Re: ***#14ITB91556K-DB***
Construction Services for the Big Creek WRF Immediate Needs Rehabilitation Project S-134

This Addendum forms a part of the contract documents and **modifies** the original ITB documents as noted below:

WAS HOPPER BRACKET
FOR SUPPORT OF CLARIFIER
CENTER MANIFOLD

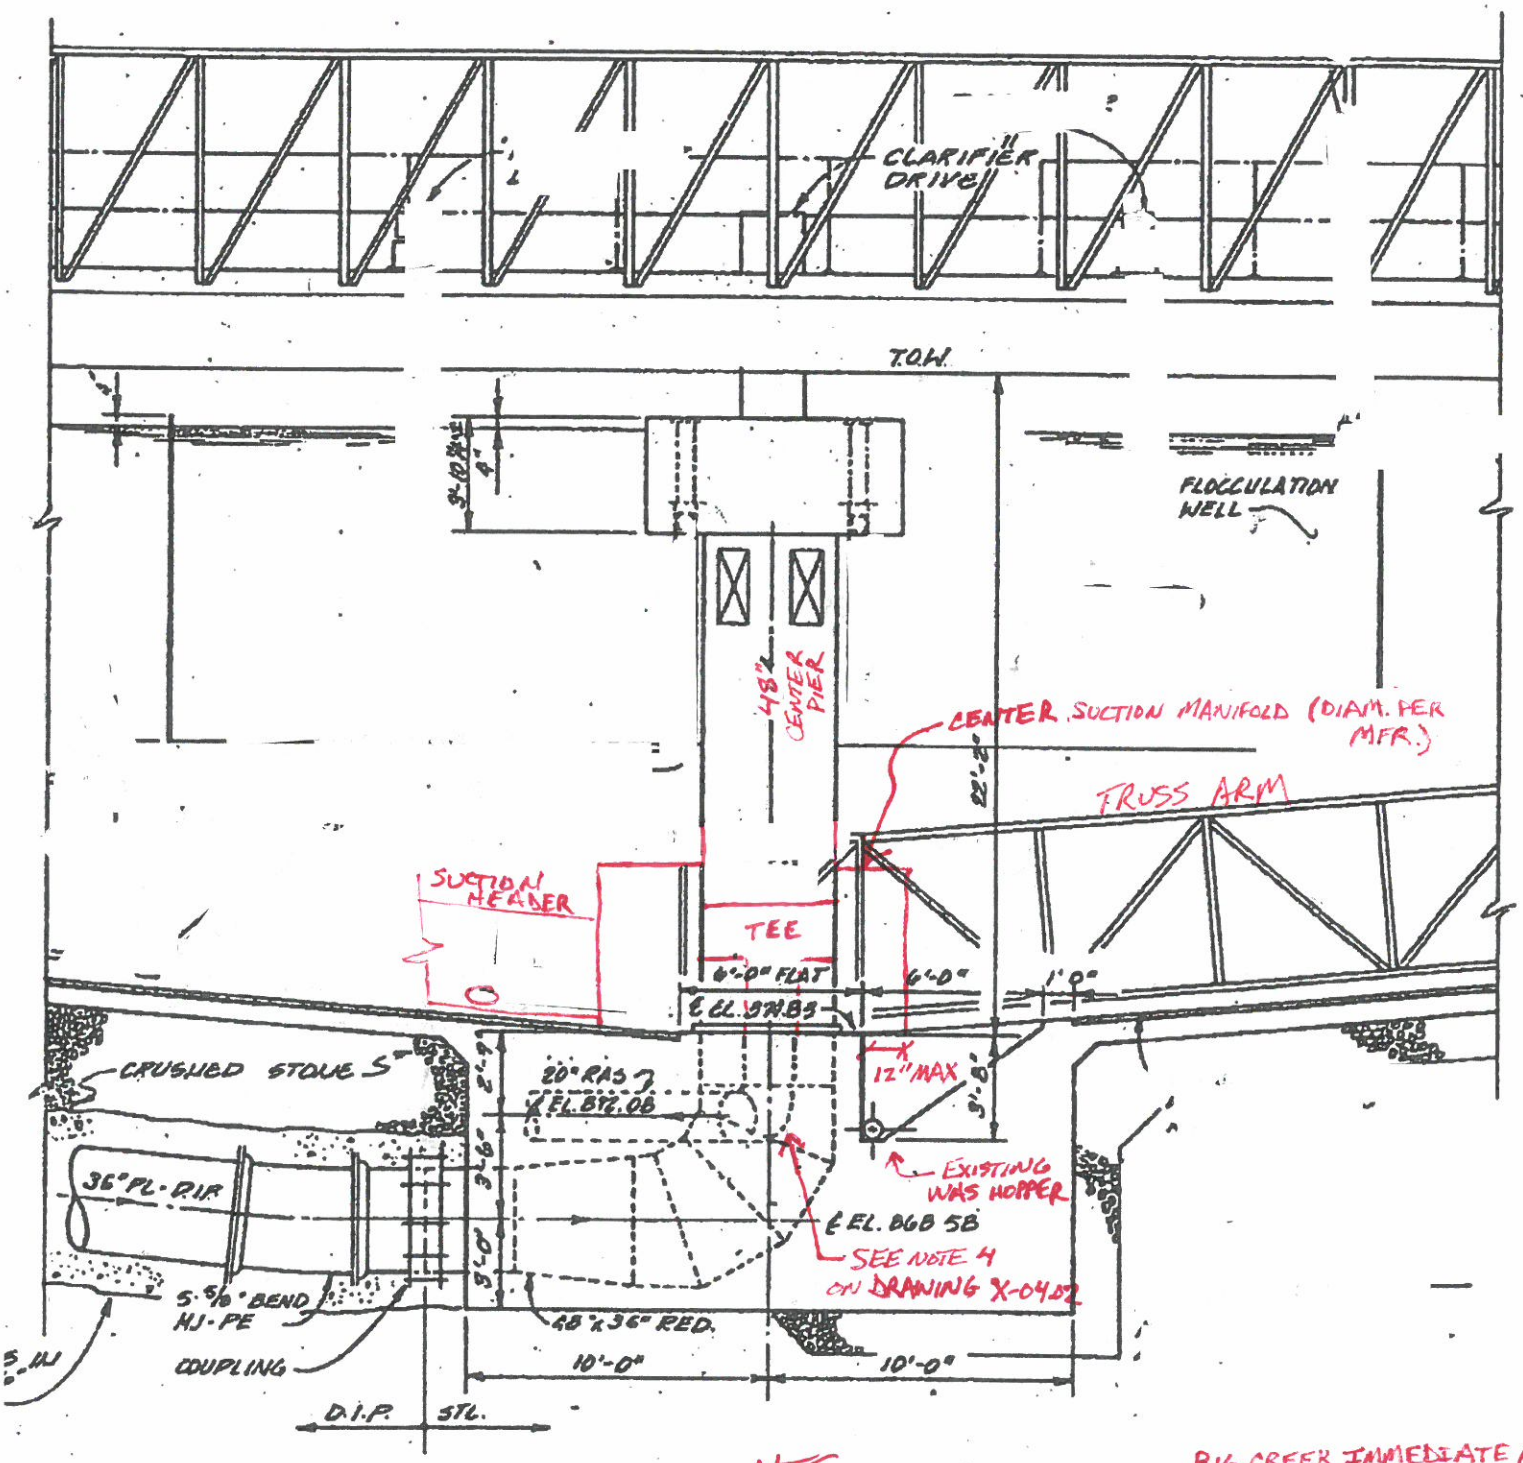
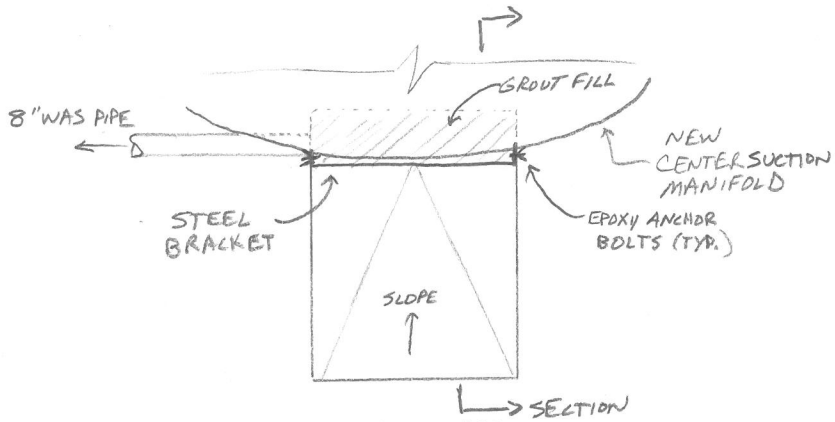
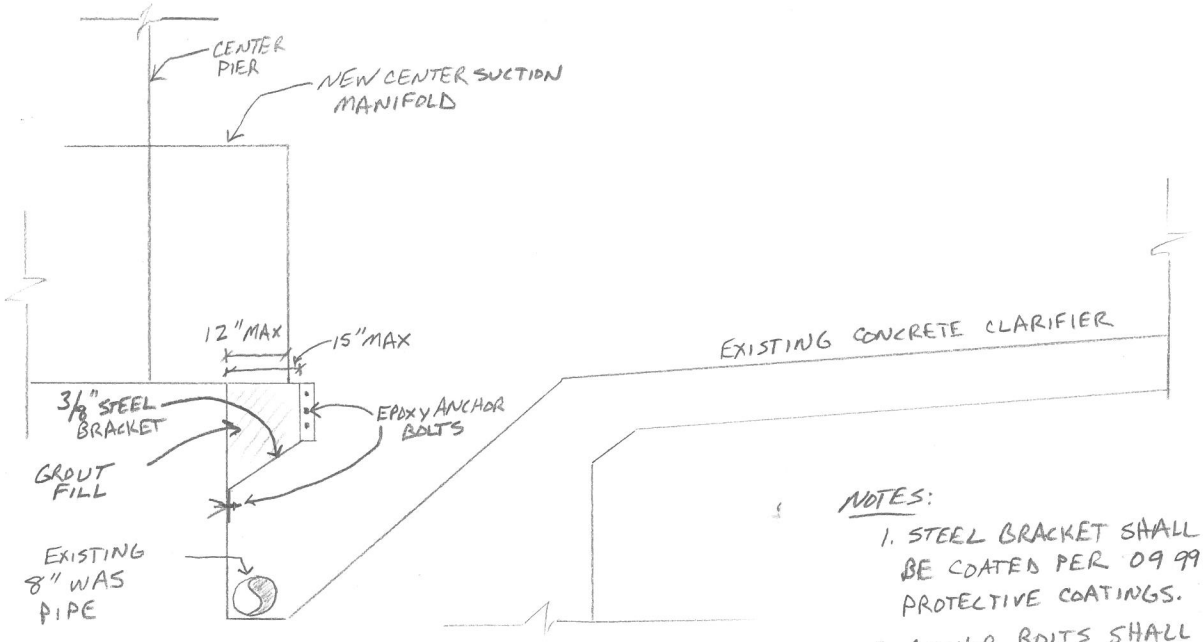
10. The center suction manifold diameter shall be limited such that it does not extend more than 12 inches into the existing WAS hopper. The cantilevered manifold shall be supported by modifying the WAS hopper with 3/8" epoxy-coated (See Section 09 9911 Protective Coatings) angled steel bracket. The void space within the angled bracket under the center suction manifold shall be grout-filled to create a smooth surface for the center suction manifold rotation.
11. Provide a center TEE connection to the existing RAS piping inside the center pier. Connection of new RAS piping through a separate hopper is not acceptable.

In addition to the above listed revisions, a sketch is attached to this addendum to clarify the modifications necessary to the WAS hopper to support a center suction manifold.

1. STEEL BRACKET SHALL BE COATED PER 09 9911 PROTECTIVE COATINGS.
2. ANCHOR BOLTS SHALL BE 316 SS.
3. CONTRACTOR SHALL FIELD VERIFY ALL DIMENSIONS.
4. STEEL BRACKET SHALL SPAN THE ENTIRE WIDTH OF WAS HOPPER.
5. QUANTITY, SPACING AND SIZE OF ANCHOR BOLTS SHALL BE DETERMINED BY CLARIFIER MANUFACTURER.
